TM 11-1223

COMPUTER TEST SET TS-909/PPM

CHANGE }
No. 6 }

COMPUTER TEST SET TS-909/PPM
INCLUDING REPAIR PARTS AND SPECIAL TOOL LISTS

Figure 19. Test setup for balance test.

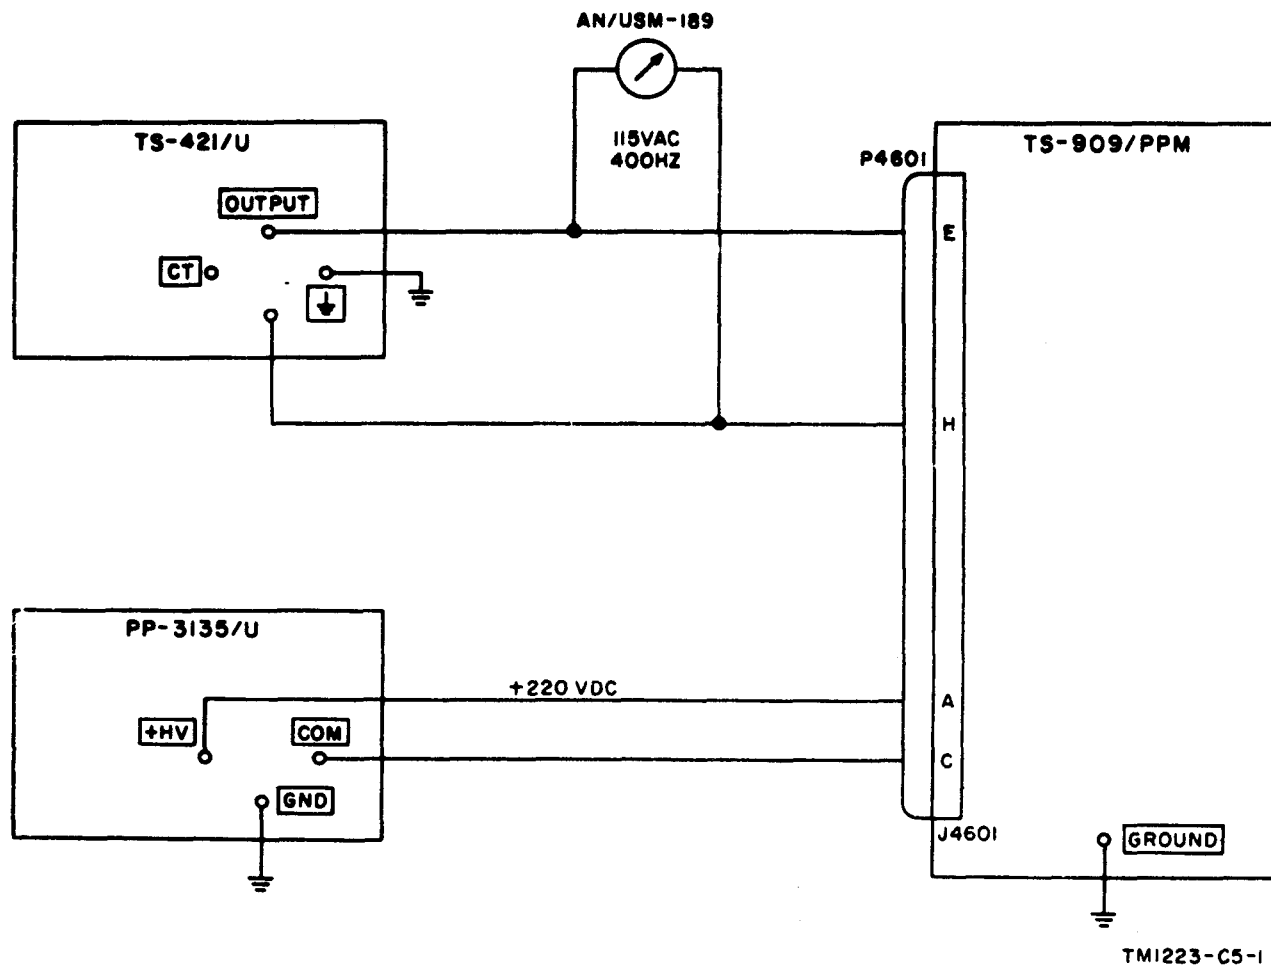
(5) Vary balance adjustment R4608 at the rear of the TS-909/PPM chassis throughout its range. Accordingly, the NULL METER needle shall deflect to right and left of zero at least 25 percent of full scale. Adjust R4608 so that the NULL METER reads zero. Remove all power.

Figure 20. Test setup for linearity, sensitivity, and resolution tests.

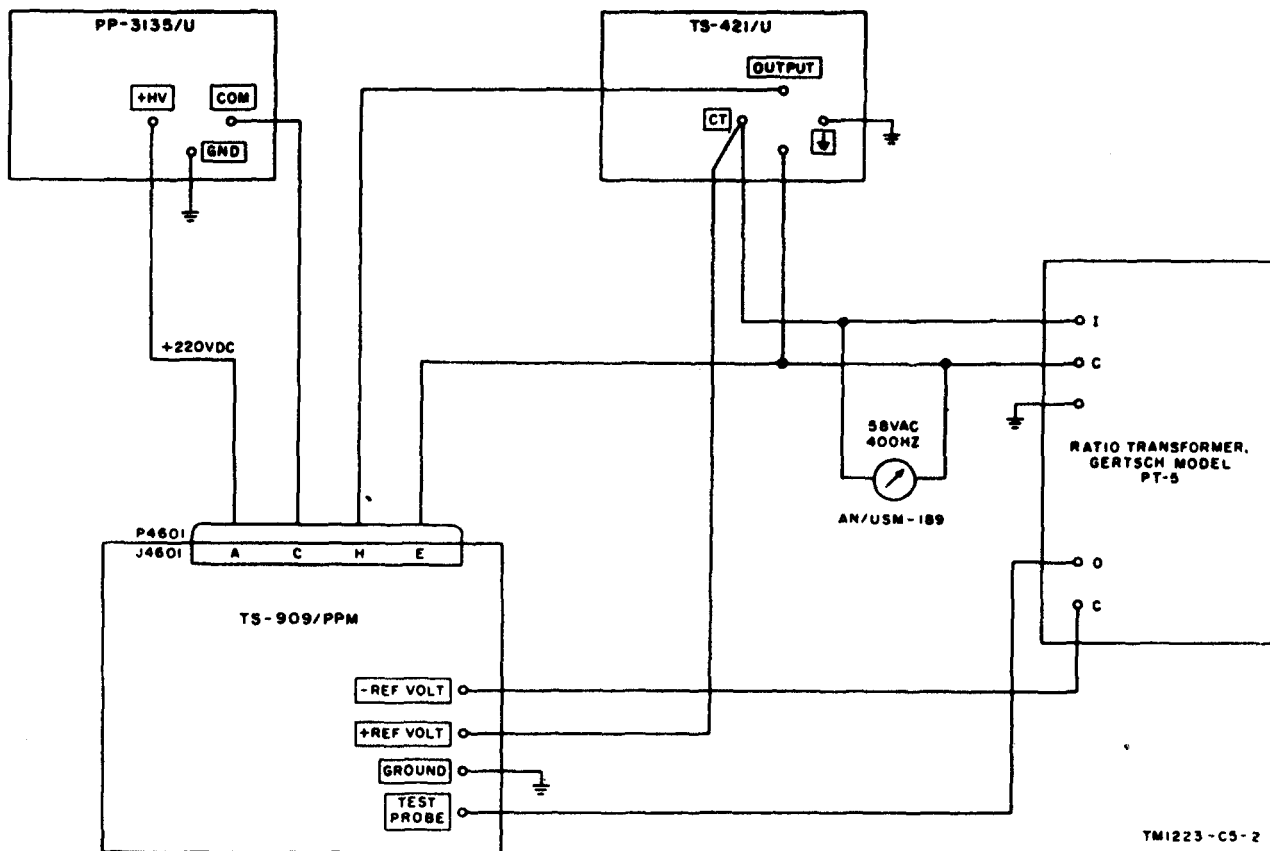
(1) Connect equipment as shown in figure 2. Adjust the TS-421/U 400-Hz output to 58 vac as indicated on the AN/USM-189.

(2) Set the ratio transformer to 0.001, and adjust the inner dial of the BRIDGE ADJ control on the TS-909/PPM for balance (zero reading) on the NULL METER. The inner dial shall indicate 1 (or 10 depending upon procurement model being tested) ± 1 minor division.

(3) Step the ratio transformer to 0.002, and adjust for a null. The inner dial on the BRIDGE ADJ control shall indicate 2 (or 20 depending upon procurement model being tested) ± 1 minor division. Repeat tests at each major division of the inner dial while stepping the ratio transformer as previously indicated. The dial indication shall be within ± 1 minor division of the major division for each test.

Figure 5. Rear view of test set chassis.

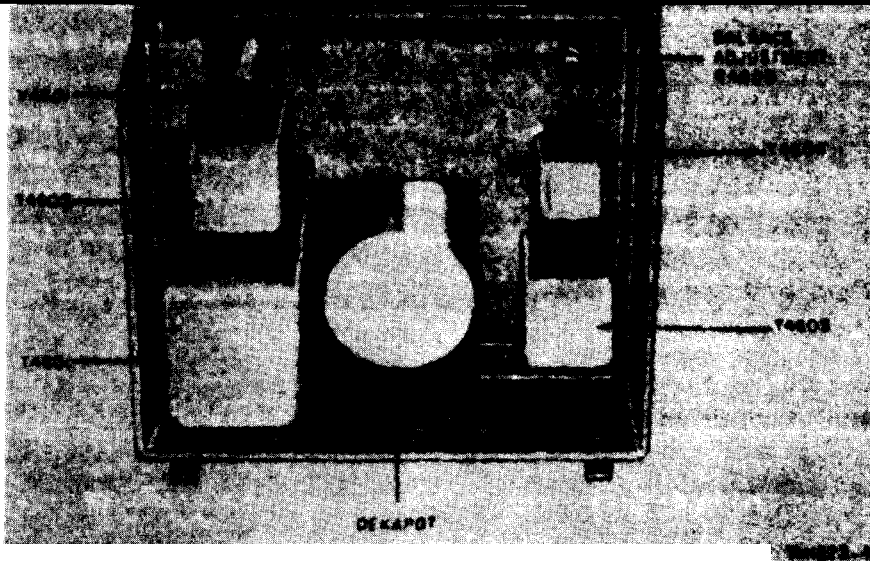
Page 10, figure 5. Below callout “DEKAPOT,” add: R4611.

Figure 15. Rear view of front panel.

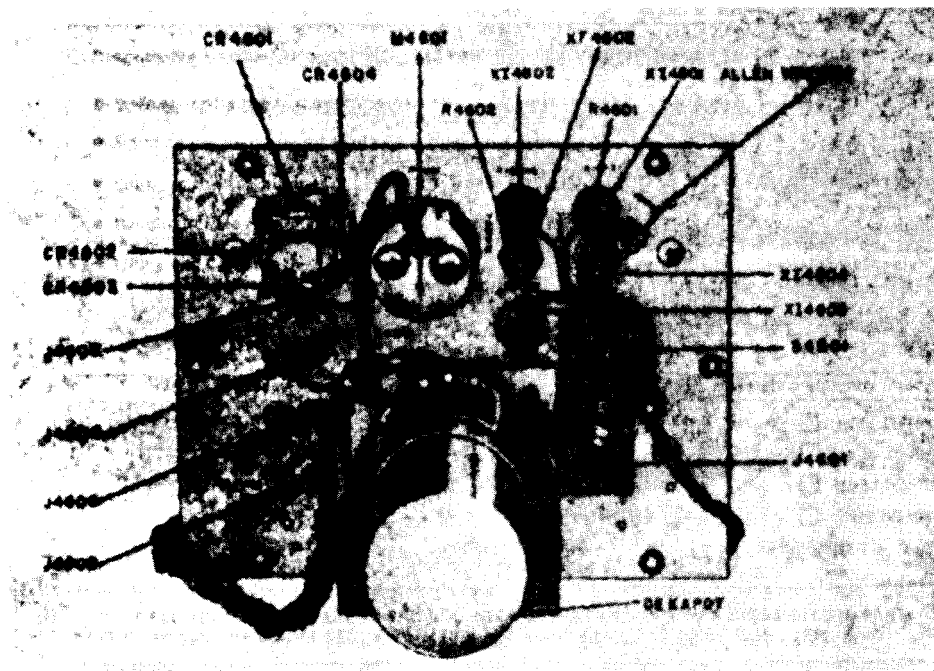
Figure 15. Under the callout "DEKAPOT" add: (R4611).
